Staff Report
City of Richmond, Virginia

Commission of Architectural Review

10. COA-105888-2022	Conceptual Review Meeting Date: 2/22/2022
Applicant/Petitioner	John Vetrovec
Project Description	Construct a new 2-story duplex with a roof-top deck on a vacant lot.
Project Location	
Address: 313-315 N. 32nd St.	
Historic District: Chimborazo Park	
High-Level Details: <ul style="list-style-type: none"> • The applicant is proposing to construct a two-story duplex dwelling on a vacant lot. • The units of the duplex will be divided vertically. The applicant notes that the proposed dwelling could be converted into a single-family dwelling in the future. • The proposed dwelling features a two story rear porch and a roof top terrace. 	
Staff Recommendation	Conceptual Review
Staff Contact	Alyson Oliver, alyson.oliver@RVA.gov , 804-646-3709
Previous Reviews	None.
Staff Recommendations	<p>Staff recommends the following:</p> <ul style="list-style-type: none"> • The proposed dwelling incorporate a design that is more compatible with the architecture featured on other dwellings found on the surrounding block. • The design of the proposed dwelling be updated so that the rear stairwell projection is

Figure 1. Vacant Lot. The proposed dwelling will be located on the southern (to the right) portion of the property.

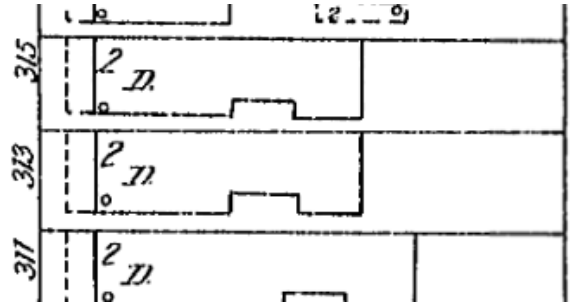
Guideline Reference	Reference Text	Analysis
Siting, #2, p. 46	<i>New residential infill construction should respect the prevailing front and side yard setback patterns of the surrounding block. The minimum setbacks evident in most districts reinforce the traditional street wall.</i>	An exhibit provided by the applicant indicates that the proposed dwelling will be setback approximately 14 feet from the property line, with the porch extending into the setback by approximately 6 feet. This is consistent with the setback of other dwellings found on the same block.
Siting, #3, p. 46	<i>New buildings should face the most prominent street bordering the site.</i>	The proposed dwelling is located along North 32 nd Street and will face the street accordingly.
Form, #1, p. 46	<i>New construction should use a building form compatible with that found elsewhere in the historic district.</i>	<p>Though the form of the proposed dwelling can be found on other dwellings within the district, it is atypical when compared to other houses found on the surrounding block. The dwellings surrounding the subject parcel feature vernacular architecture with asymmetrical cross-gable roofs and projecting bays (see Figures 1 and 3).</p> <p><u>Staff recommends the proposed dwelling incorporate a design that is more compatible with the architecture of other dwellings found on the block.</u></p> <p>Staff also notes that the proposed design incorporates a rear stairwell projection, which provides access to a rooftop deck. This is also a form that is not typically found in the district. <u>Staff recommends that the design of the proposed dwelling be updated so that the rear stairwell projection is less prominent, better blends with the design of the rest of the dwelling, or is better screened.</u></p> <p>Redesigning the roof-form on the front façade in a way that makes the proposed architecture more compatible with the surrounding architecture may allow opportunities to better blend or screen the stairwell projection into the overall design.</p> <p>Staff also notes that the folding door proposed on the north façade is not a typical element found in the district.</p>
